NEXTERA ENERGY DUANE ARNOLD, LLC  
DUANE ARNOLD ENERGY CENTER

NG-19-0017

LICENSE AMENDMENT REQUEST (TSCR-182)

**License Amendment Request (TSCR-182): Proposed Changes to the Emergency Plan for Permanently Defueled Condition**

Figure B-1  
 ONSITE EMERGENCY RESPONSE ORGANIZATION  
 (Page 1 of 2)

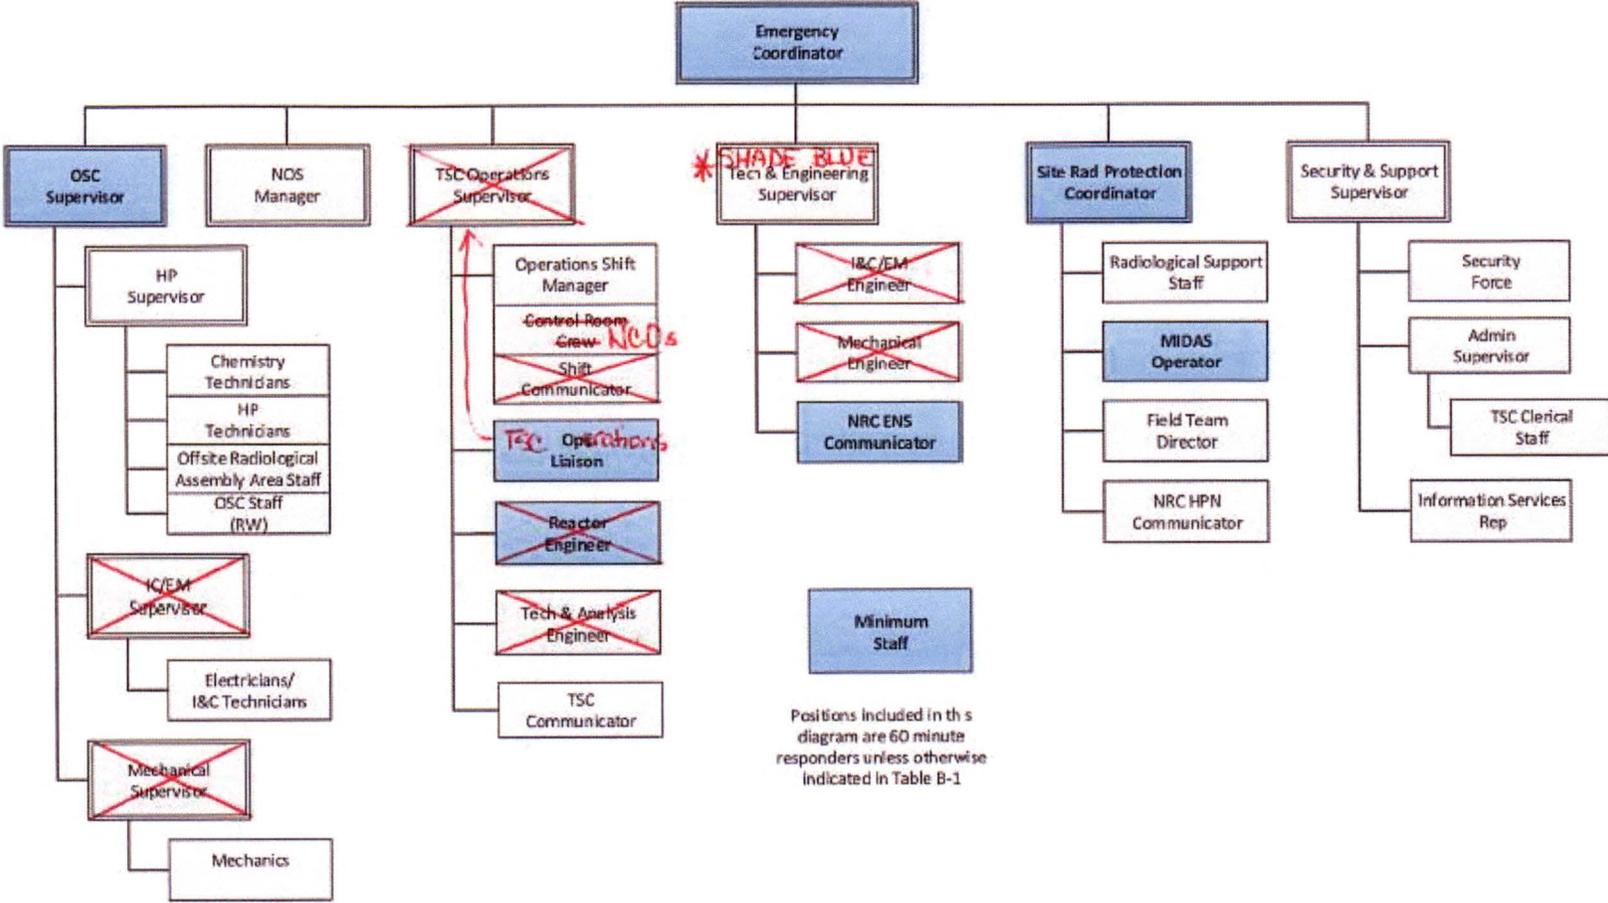
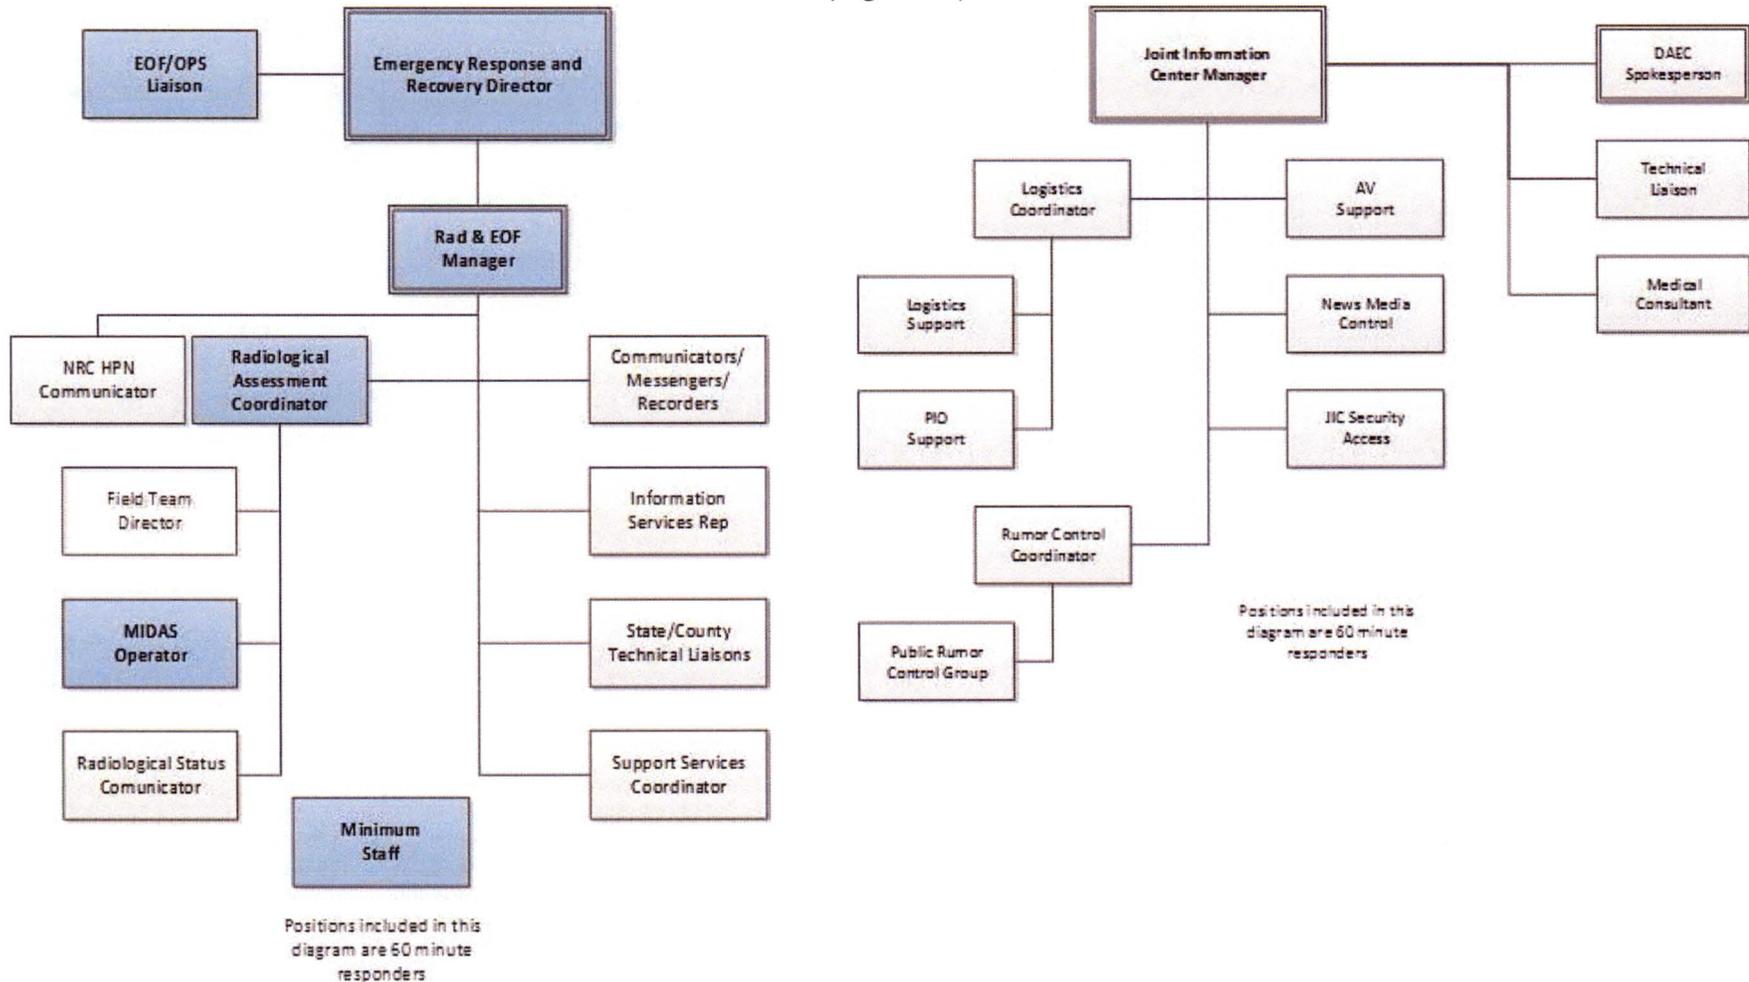
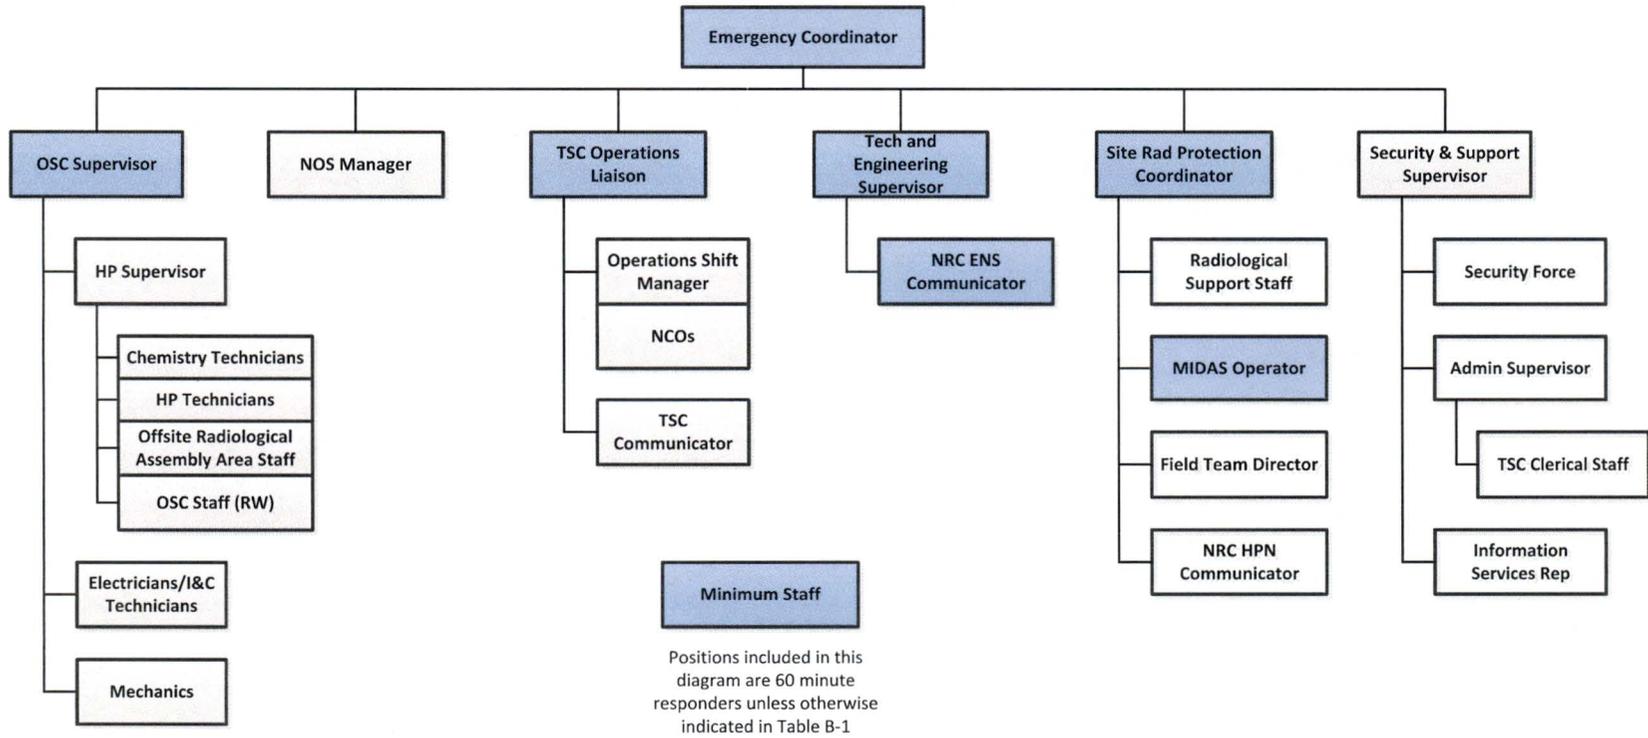
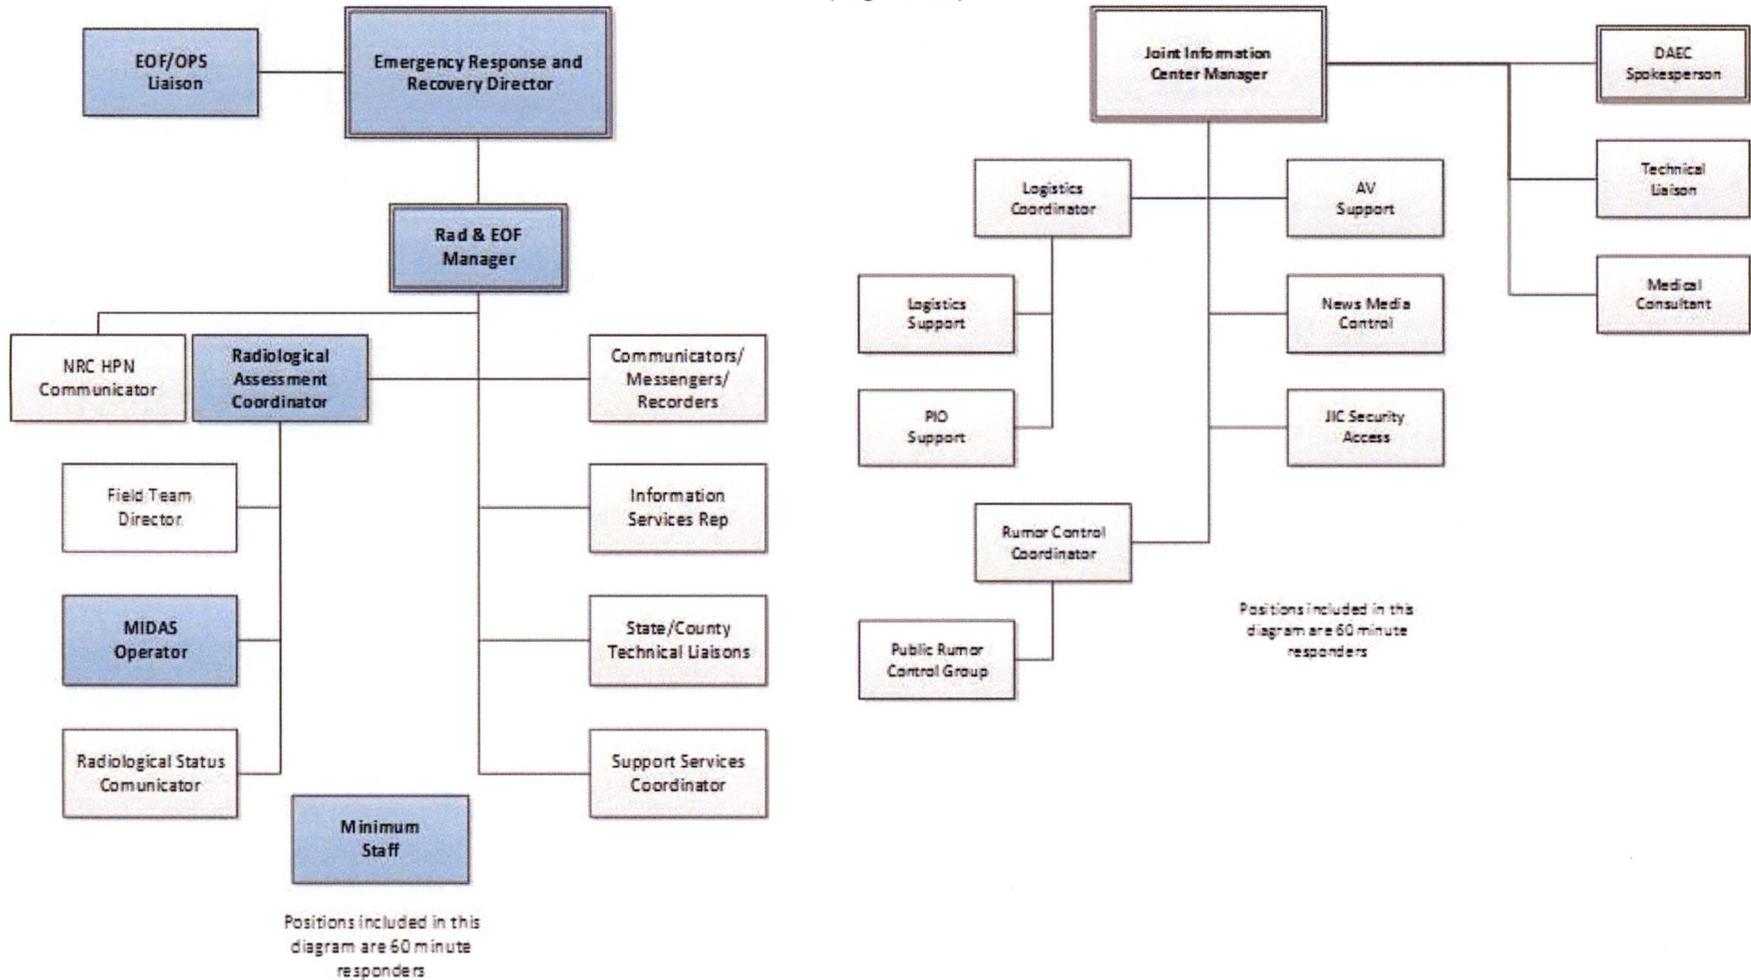
The proposed changes would eliminate the following ERO positions identified in Figure B-1 of the DAEC Emergency Plan, Section 'B':
